1141 MARTIN LUTHER KING WAY, SEATTLE WA 98122

PROJECT NUMBER: 3015747

DESIGN REVIEW RECOMMENDATION PROPOSAL PACKET

1 LANDSCAPE PLAN: LEVEL 2 COURTYARD
SCALE: 1" = 10'-0"

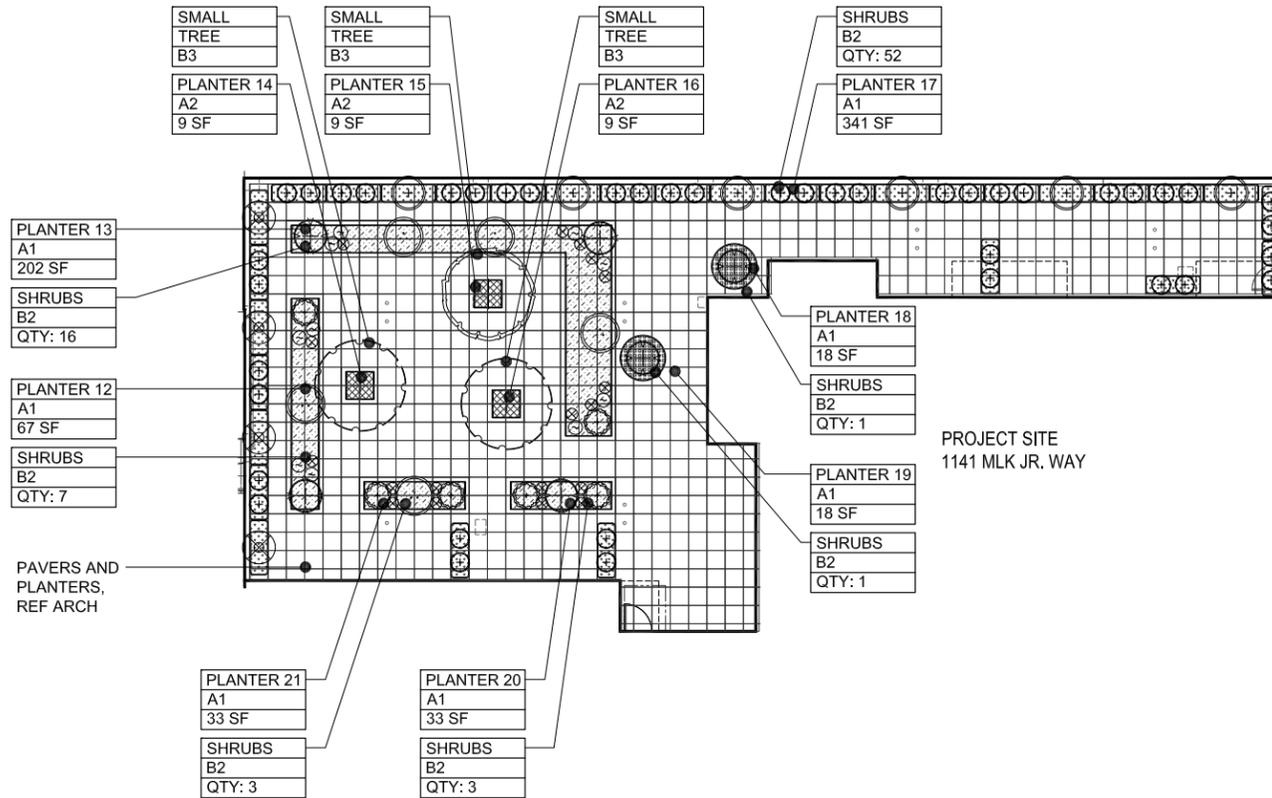
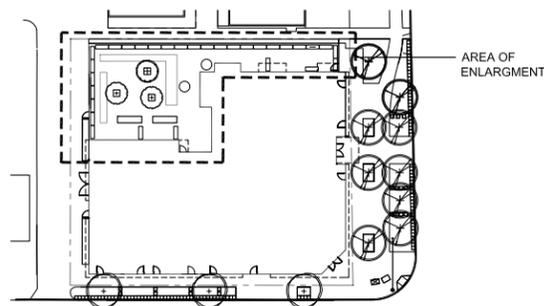
By the Recommendation meeting, provide sections and elevations of the courtyard particularly of the terracing above the garage ramp. The garden has three elements the pathway circumnavigating it, the seating area and the terrace above the garage ramp. Illustrate the terrace walls and the how the courtyard functions.

-See landscape drawings. We have eliminated the terraced landscaped areas above the garage ramp. The courtyard has moved to the residential level of our building. The new courtyard design delineates public and private resident zones- with the private ones abutting residential units on the 2nd level, and the central courtyard being used by all residents. Because of the simplicity of the new courtyard location, no sections and elevations are required.

DEPARTURE #1 (AS PROPOSED)
1/8"=1'-0" → N

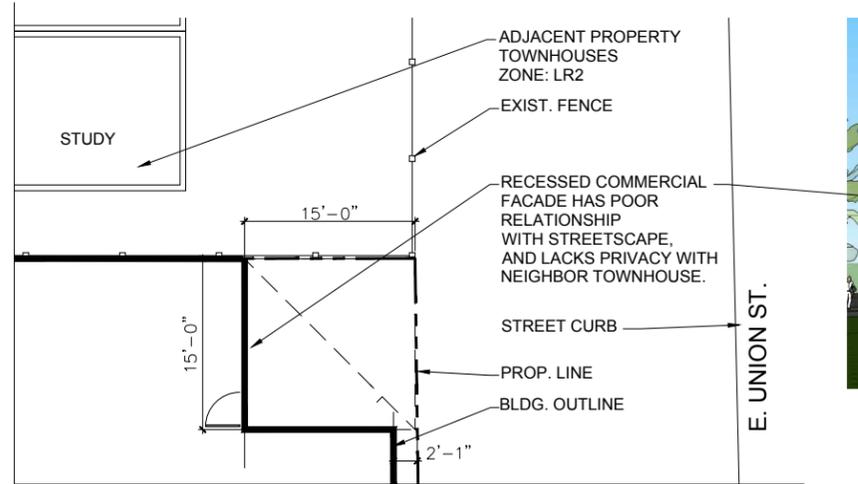
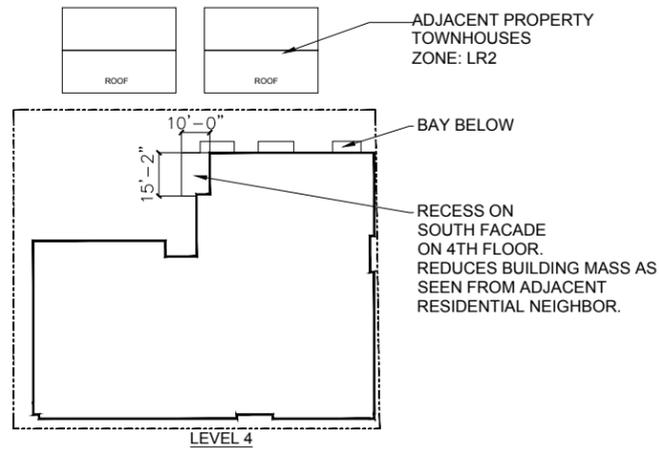
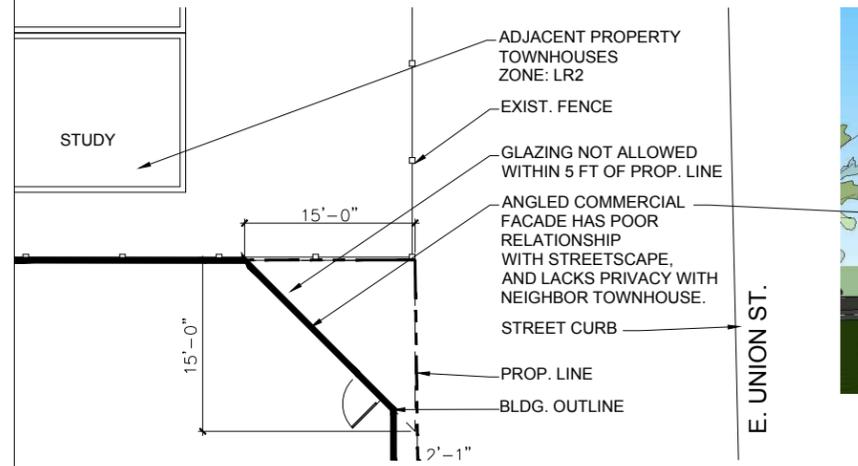
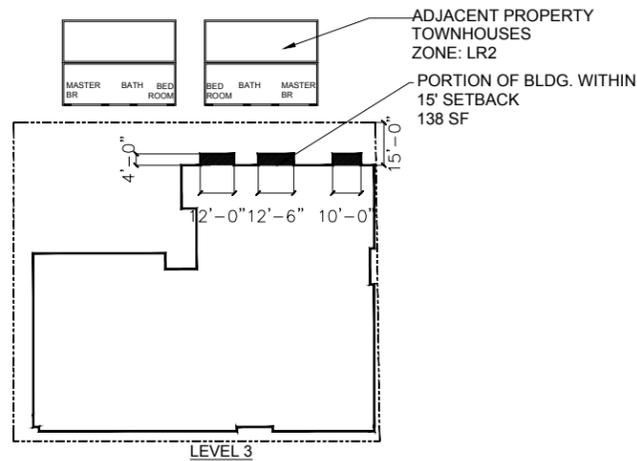
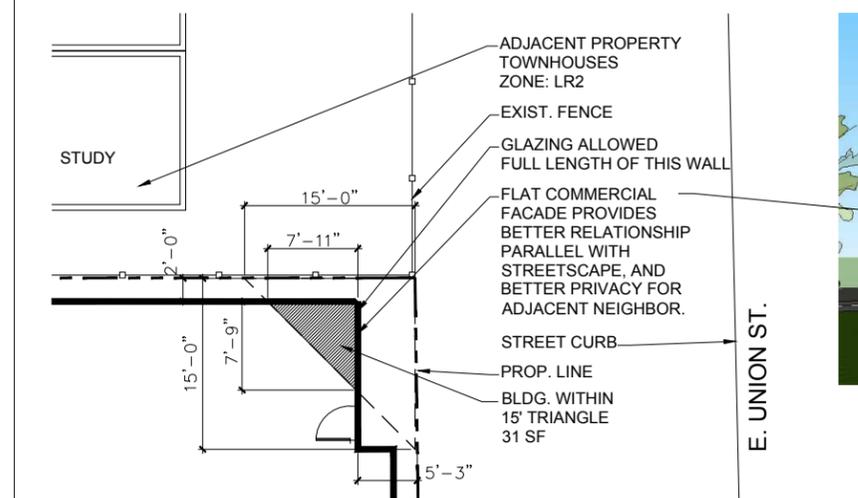
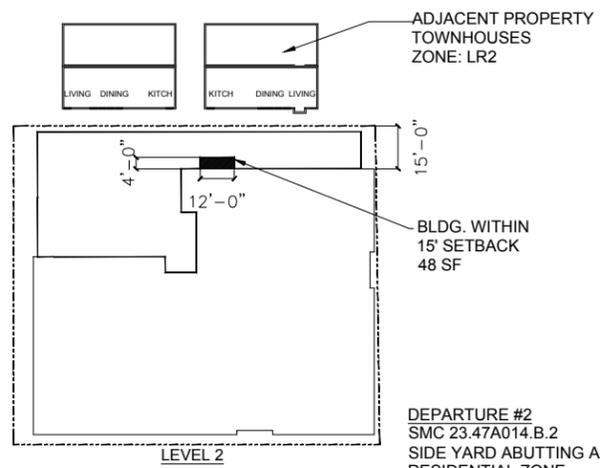
Departure #1: (SMC 23.47A.014.B.1) 15' triangle at side yard abutting a residential zone.

The proposed design encroaches into this triangle in order to provide street facing commercial frontage space. Diagrams show that code compliant frontage would create either a 15' recessed retail which is too far back to engage the street or an angled frontage which faces the adjacent townhouse fence and has an awkward relationship to the street. Our proposed solution reinforces and complements the rest of the commercial street frontage along MLK and E. Union St. See departure diagram on sheet A1.1

DEPARTURE #2
1/32"=1'-0" → N
SMC 23.47A014.B.3a
SIDE YARD ABUTTING A RESIDENTIAL ZONE

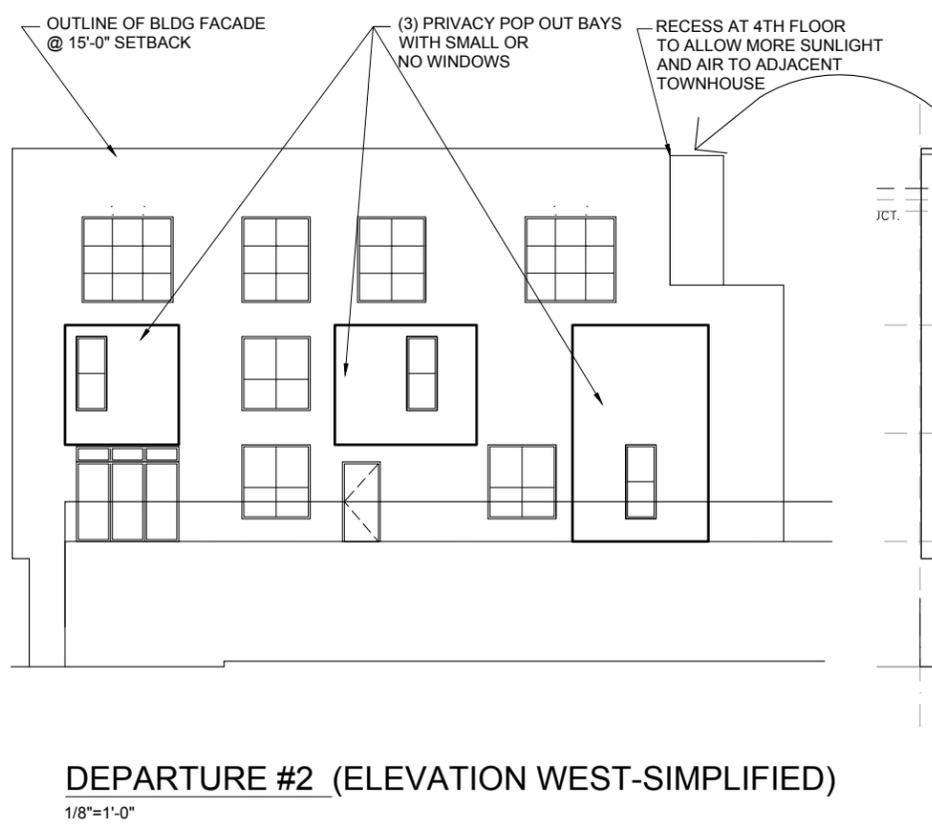
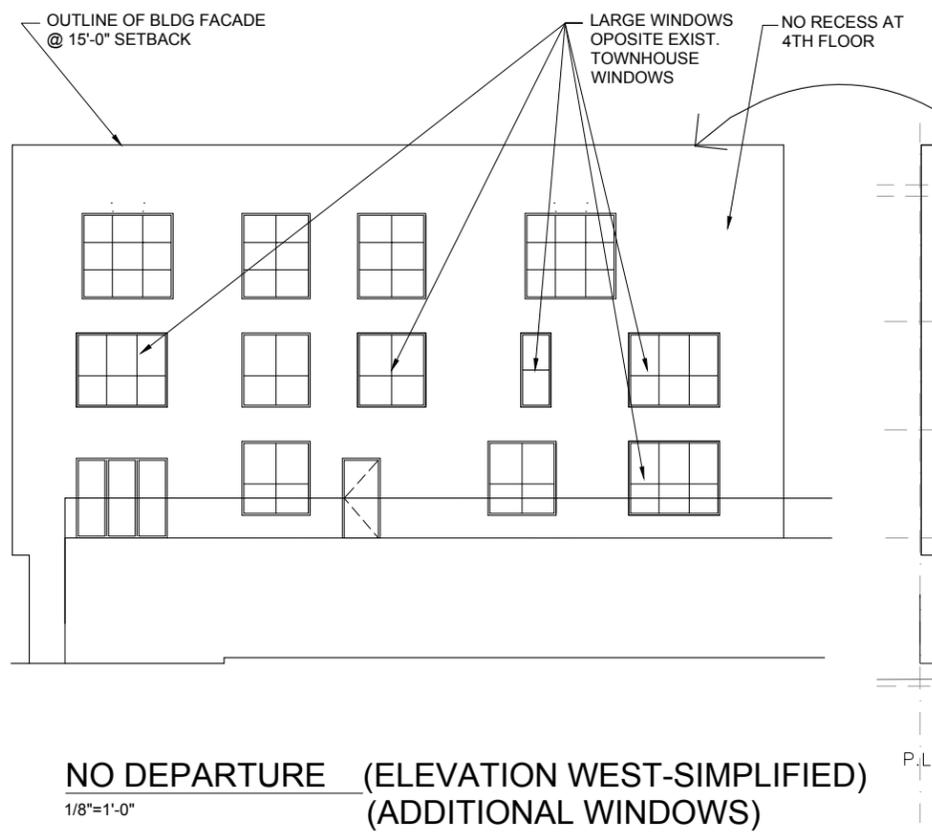
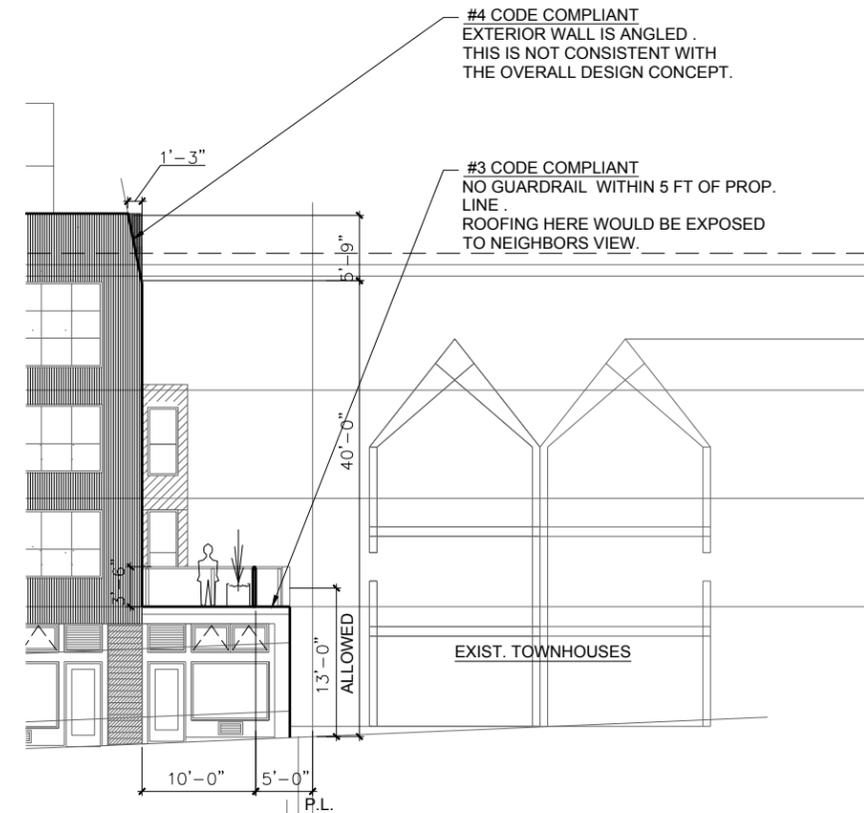
Departure #2: (SMC 23.47A.014.B.3a) 15' Setback at side yard abutting a residential zone.

The proposed design proposes pop-out privacy bays that encroach 4' into this setback. These bays have either no windows or narrow windows facing the adjacent townhouses. Rather than large windows facing directly opposite the townhouse which would be permitted with a 15 foot setback, our proposed bay have limited openings which helps preserve the privacy of our neighbors to the West. See departure diagram on Sheets A1.1 and A1.2 and section A-6 "Respect for adjacent sites".

DEPARTURE #3 AND DEPARTURE #4

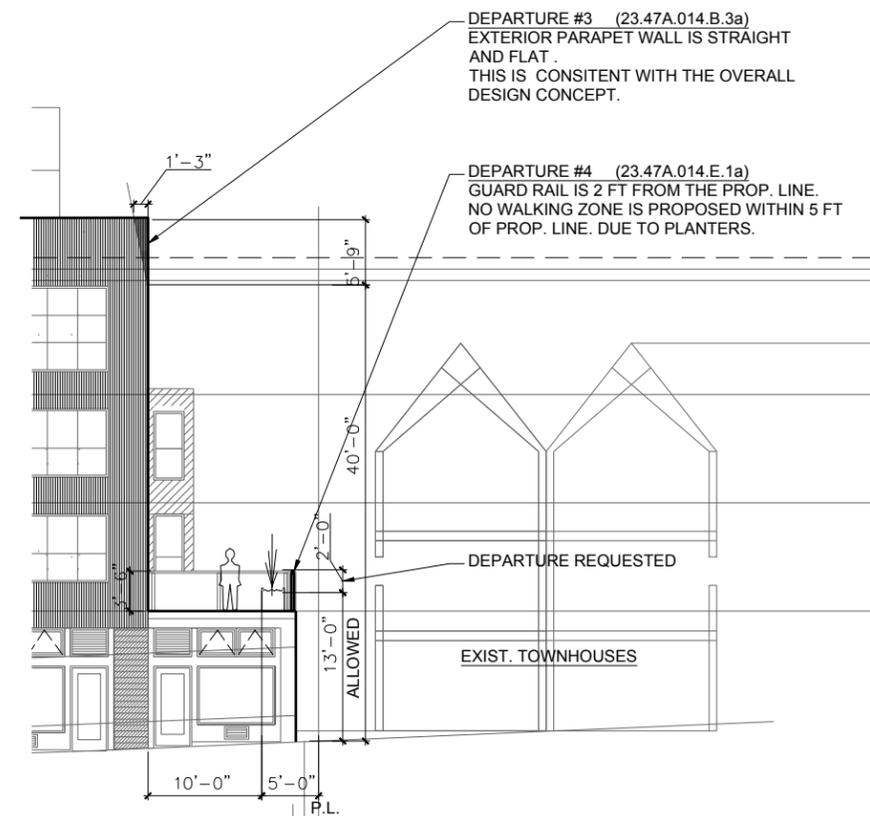
Departure #3: (SMC 23.47A.014.B.3b) For structures above 40 feet, an additional setback at the rate of 2 feet of setback for every 10 feet by which the height of such portion exceeds 40 feet.

Our proposed building is allowed a building height to 44 feet, based on the commercial level on grade being 13 feet in height. The 4 foot in height above 40 feet triggers this section of the code. We want to keep our building's West wall aligned and straight, and unfortunately, this code section would require us to set back the top 4 feet of our building an extra nine inches. We are asking a departure for this extra nine inch required setback. See departure diagram on Sheet A1.3.

Departure #4: (SMC 23.47A.014.E.1.a) Decks with guard railing are not permitted within 5 Ft of a lot line. The Proposed guard rail is 2 ft from prop. Line. The guard rail with adjacent landscape planters will provide privacy screening for adjacent neighbors. Guard rail extends vertically 2' above the 13 ft limit from grade. We are requesting a departure. See departure diagram on Sheet A1.3.
